MANCHESTER CTR AIRSPACE CHANGE PROPOSAL

CONSULTATION FEEDBACK
ISSUE 1 - JUNE 2011

**MAP ONE
CTR BOUNDARIES BEFORE AND AFTER PROPOSED CHANGE.**

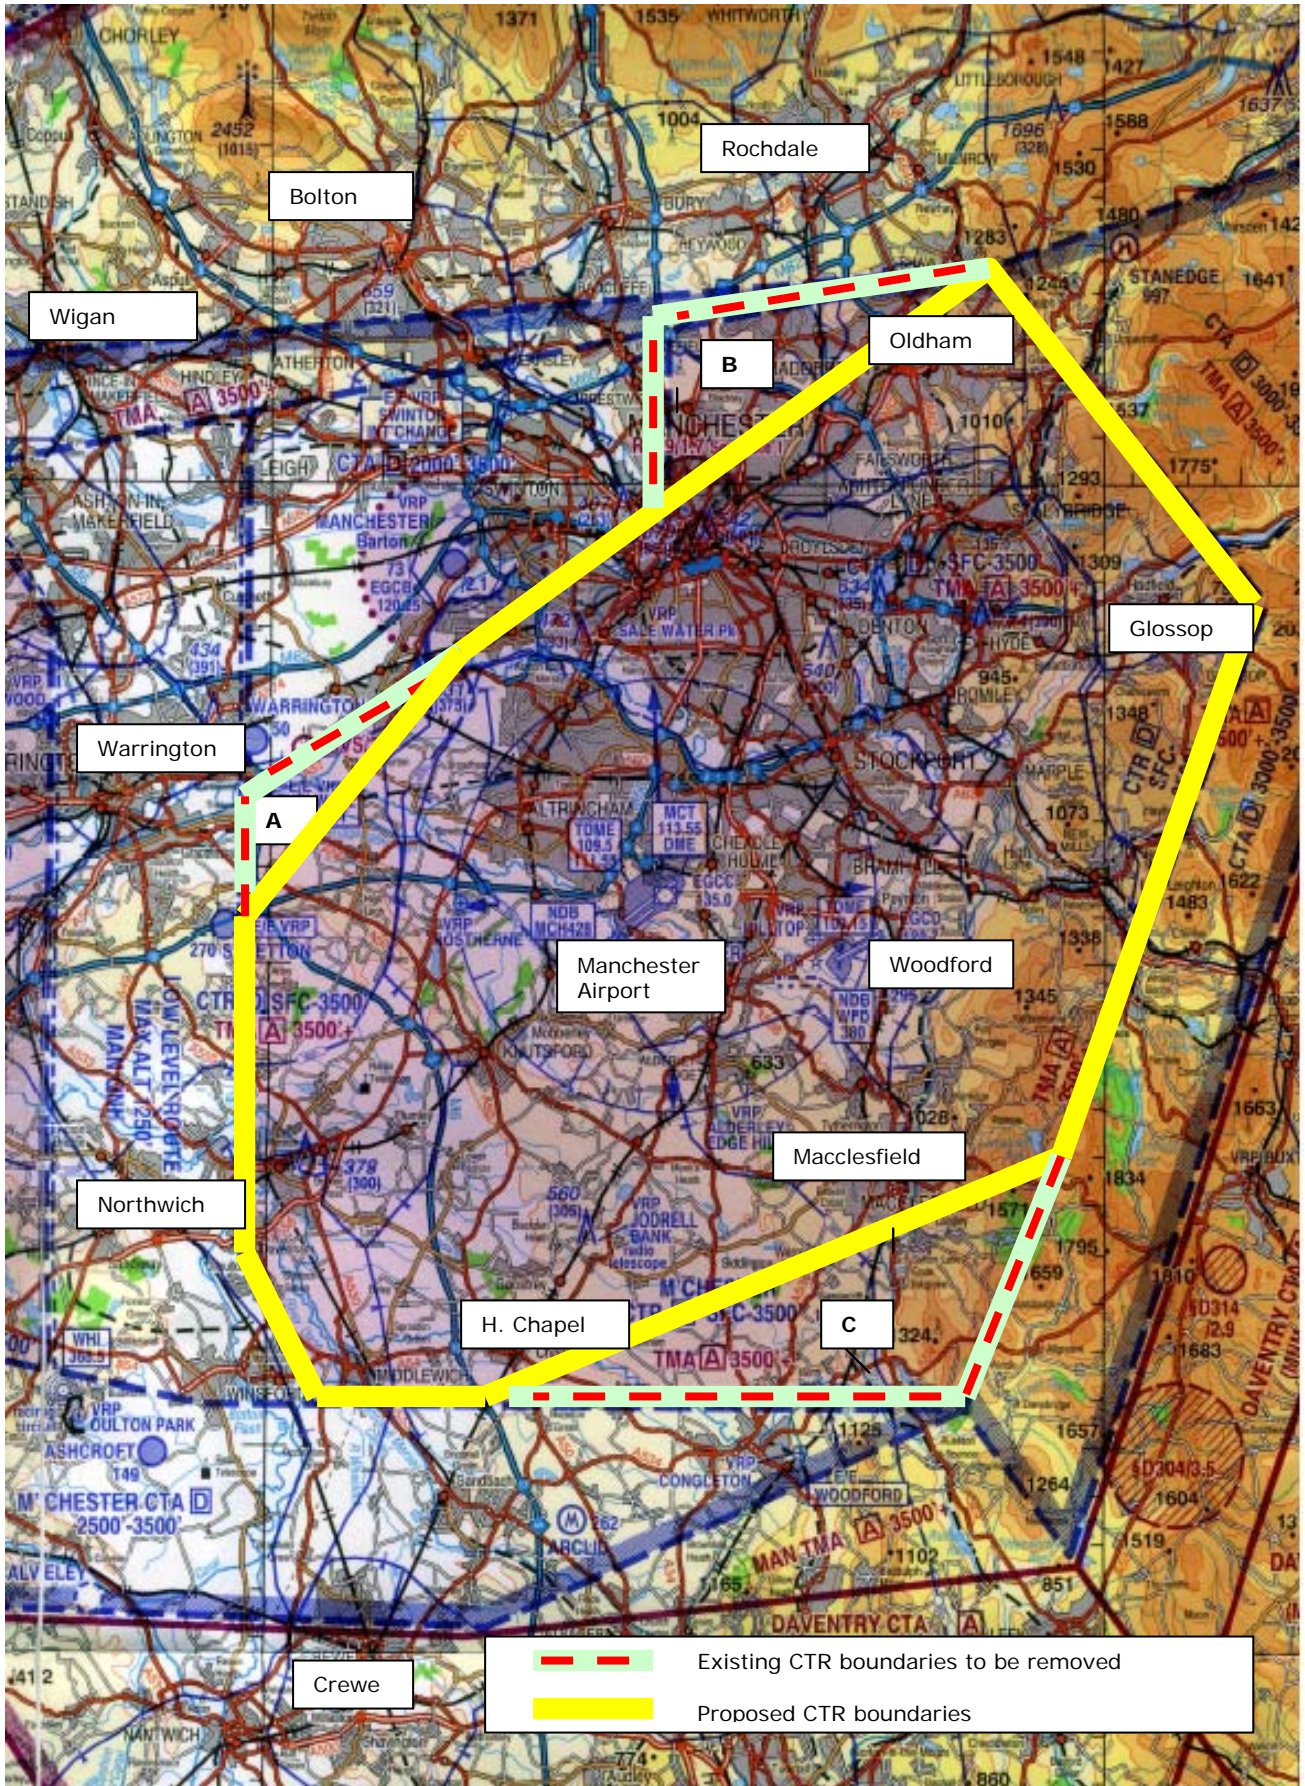
- 5.9 **Low Level Route – Lateral Limit.** Extending the lateral limits of the LLR was another of the main issues raised during the Consultation Stage. This issue has been given much consideration, but the only change proposed will be to returning a portion of airspace to the east of the LLR (north east of Stretton VRP) to Class G airspace. This increase in Class G airspace has been well received, particularly amongst pilots using Manchester Barton. One response questioned the reason behind the 'kink' in the revised boundary between Stretton VRP and Oldham. This is due to the protection required for the POL & DESIG outbound SID climb profiles, which are based on multi-engine aircraft's engine out performance.

- 5.12 **CTR – Lateral Limit.** Responses welcomed the additional fillet to the north-east of the CTR, which they view as a lateral improvement. Further suggestions though requested that the south east CTR boundary could be taken back on a line towards Glossop. This could bring unknown north east bound traffic (following the edge of higher terrain to the east of the Manchester basin) on a converging track with the 23R final approach. The presence of low cloud which often occurs around the high ground to the east could result in traffic taking a more westerly track, flying even closer to the final approach at Manchester. Northbound traffic remaining clear of cloud, tracking to the west of this high ground could encounter further low cloud over the high ground in their twelve o' clock, north of Glossop. This could lead to a scenario where the traffic alters course onto a southerly track, again close to the extended final approach track.

6.1 North Western CTR boundary realignment – shown as A on Map One

1. To realign the North Western boundary of the CTR thereby creating a new “fillet” of Class G airspace from a point where the M56 Motorway crosses the existing Eastern LLR boundary at $53^{\circ}20'56''$ N, $002^{\circ}31'03''$ W (abeam Stretton VRP), to a point $53^{\circ}26'38''$ N, $002^{\circ}22'58''$ W (near Flixton Railway Station).
2. The fillet would extend to 2000 feet amsl. The airspace above 2000 feet up to 3500 feet amsl would be absorbed into the existing Class D CTA.

6.2 Northern CTR boundary realignment – shown as B on Map One

1. To extend the Northern boundary of the Manchester CTR from $53^{\circ}26'38''$ N, $002^{\circ}22'58''$ W (Flixton Railway Station) Northeastwards to the existing Northernmost point of the CTR at $53^{\circ}34'30''$ N, $002^{\circ}04'00''$ W (near Shaw and Delph).
2. A portion of the current Class D airspace in the North East quadrant of the CTR would be reclassified to Class G extending to 2000 feet amsl.
3. The airspace above 2000 feet up to 3500 feet amsl would be absorbed into the existing Class D CTA.

6.3 Southern CTR boundary realignment – shown as C on Map One

1. To realign the Southern boundary of the Manchester CTR Northeastwards from 53° 10' 55" N, 002° 22' 07" W (Holmes Chapel VRP), to pass South of Macclesfield, to intersect the existing eastern CTR boundary at 53° 16' 16" N, 002° 01' 31" W (near Lamaload Reservoir VRP).
2. Class G airspace up to 2500 feet amsl would replace the existing Class D airspace.
3. The airspace above 2500 feet amsl up to 3500 feet amsl would be absorbed into the existing Class D CTA.

6.4 Low Level Route

1. To raise the upper limit of the LLR to 1300 feet in accordance with CAA DAP requirements.
